TENNESSEE VALLEY AUTHORITY

In the Matter of the Application of) Docket Nos. 50-327
Tennessee Valley Authority) 50-328

On January 16, 1980, a meeting was held at Sequoyah Nuclear Plant with NRC-NRR Consultant R. M. Gustafson and TVA employees to discuss welds on pressurizer relief piping. During this meeting, Mr. Gustafson requested additional information which was not available at the plant site. Enclosed is the requested information.

ADDITIONAL INFORMATION ON PRESSURIZER RELIEF LINE
DRAW BEAD ALIGNMENT WELDS

PRESSURIZER RELIEF PIPING SKETCH

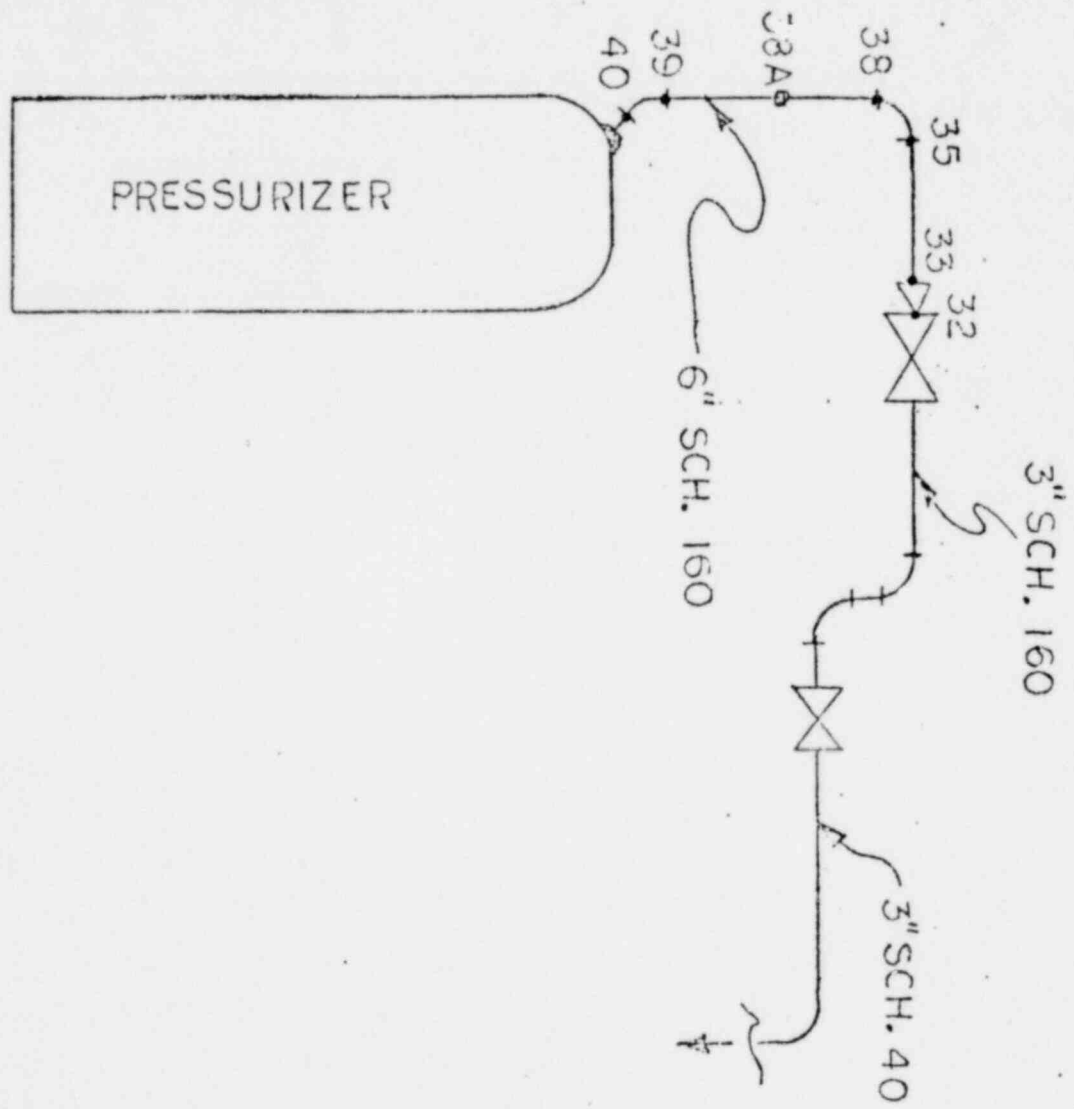
During the hot functional test, a pipe support providing restraint in the lateral direction failed to slide as designed, restraining the pipe in the vertical direction. The restraint is located at joint 33 shown on the sketch in enclosure 1. A copy of the restraint design is shown in enclosure 2.

The maximum anticipated vertical movement at joint 33 during normal operation was anticipated to be 2.87 inches assuming a worst case operating temperature of 653° F. The hot functional test had proceeded to an operating temperature of approximately 550° F at the time of discovery of the bound up support. The U-bolt which restrained the pipe in the vertical direction was deflected approximately one inch vertically.

In order to determine the stress levels due to the bound support, an analysis was run with the piping at 550° F and a vertical restraint installed at joint 33. The vertical restraint was free for the one-inch vertical movement simulating the one-inch deformation of the U-bolt. The stress levels for the joints shown in enclosure 1 are tabulated in enclosure 3. These stress levels are below the ASME, Section III allowable stress for nonrepeated stresses as defined by NC-3611.2(f). That allowable stress for A-376T316 is 60,000 lb/in². Pressurizer relief nozzle loads for this anomaly load case were forwarded to Westinghouse for review by enclosure 4 and were approved by enclosure 5.
